**Planning Staff Report  
to the Allentown City Planning Commission  
January 10, 2023**

**Project Title (Number):** Hanover Apartments (LMA-2022-00023)

**Type:** Major Land Dev't / **Sketch** Plan

RE: 2300 Hanover Avenue  
(LMA-2022-00023)

Fig-2. East Allentown and the project site as seen through Vision 2030.

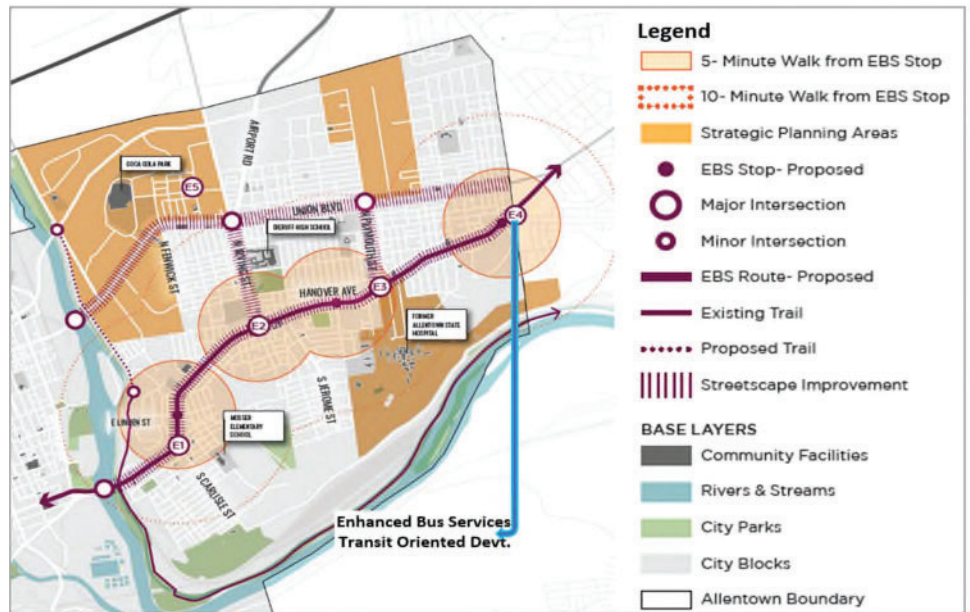
9. In support of this prospect, the project site is within what LANTA calls Enhanced Bus Service route through which LANTA plans to provide fast, frequent, and comfortable transit service along a dedicated corridor, such as this busy junction of Hanover Avenue and Broad Street.

10. Moreover, Vision 2030 foresaw this specific location as a promising site for mixed-use infill opportunities, specifically mixed residential-commercial-office (p. 196).

- a. *Although the proposed project will only contain multi-unit residentials, it is still deemed consistent with the vision of the comprehensive plan for this area of Allentown.*

Fig-4. Site plan of the proposed apartment complex in sketch.

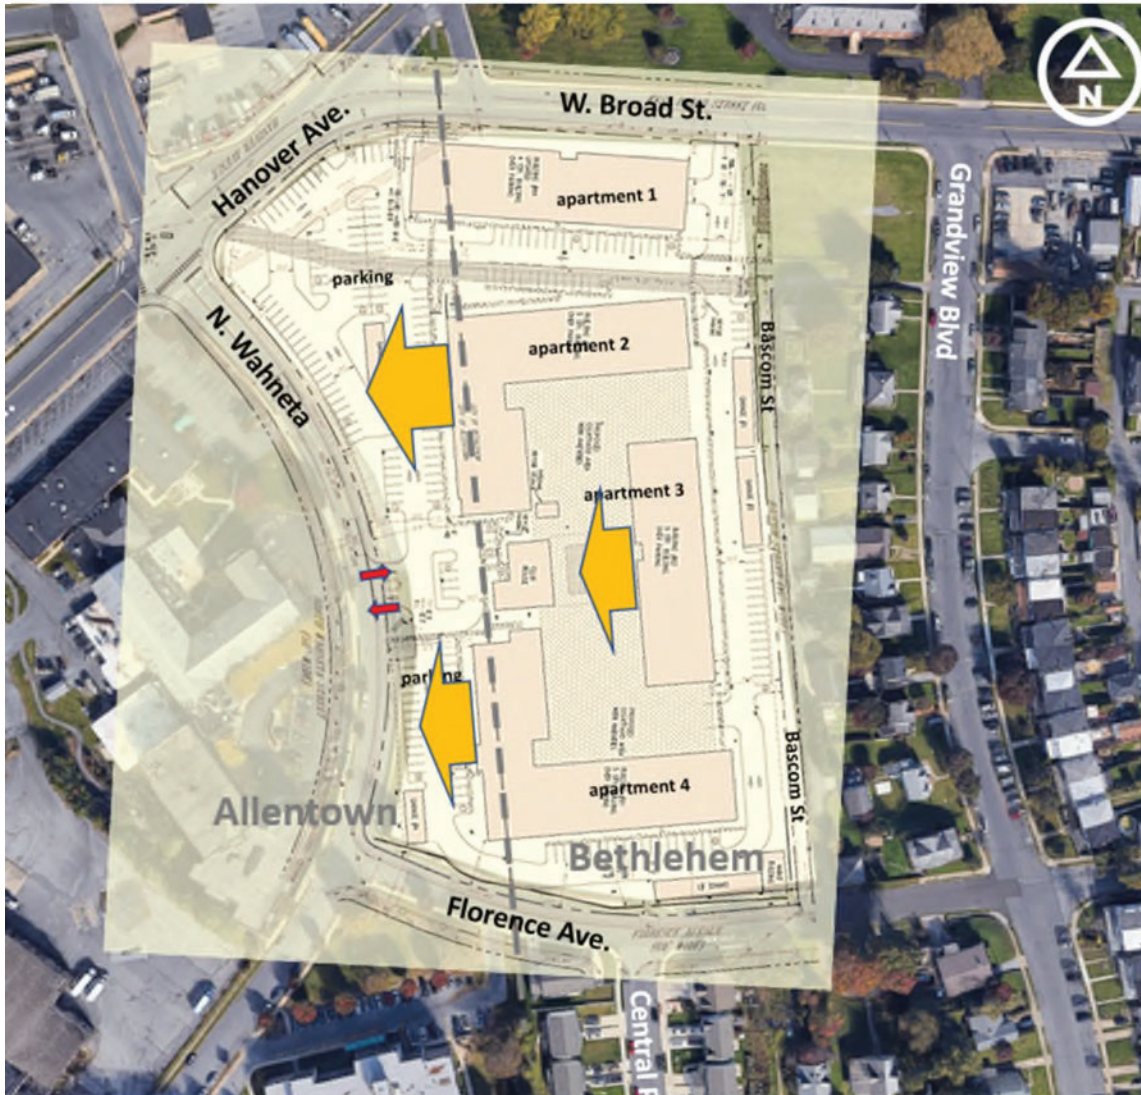
11. The sketch plan suggests using N. Wahneta Street as the primary façade for the envisioned development such that the main access point shall be located on this street (as indicated by the red arrows in Figure 4), and that all four 4 buildings will have a facet oriented towards Wahneta.

12. Likewise, the sketch plan proposes to locate most of the parking along Wahneta and Hanover – that is, 2 to 3 rows of parking between the buildings and the west property line -- and that all the buildings will be sited towards the rear (i.e., the east side) of the parcel.

- a. *The choice of N. Wahneta St. as location for the primary access to the development makes sense given that Wahneta seems less busy – traffic wise – compared to Hanover and West Broad. The new vehicular traffic that will be generated by more than 300 households would be undoubtedly huge.*

- b. *With reference to siting the buildings towards the rear in favor of locating the parking lots in front, however, does not make good planning sense. Rather, the staff recommends moving the building lines nearer to the street (as suggested by the orange arrows in Fig-4), with due regard to observing zoning setbacks. This action:*

- i. *Affords the buildings a better relationship with the public realm in terms of better street appeal, and a high perception of pedestrian safety and therefore higher pedestrian activity.*

- ii. *Show cases the facades of the new buildings and minimizes the visual presence of the parking lots from public view, which is proper.*
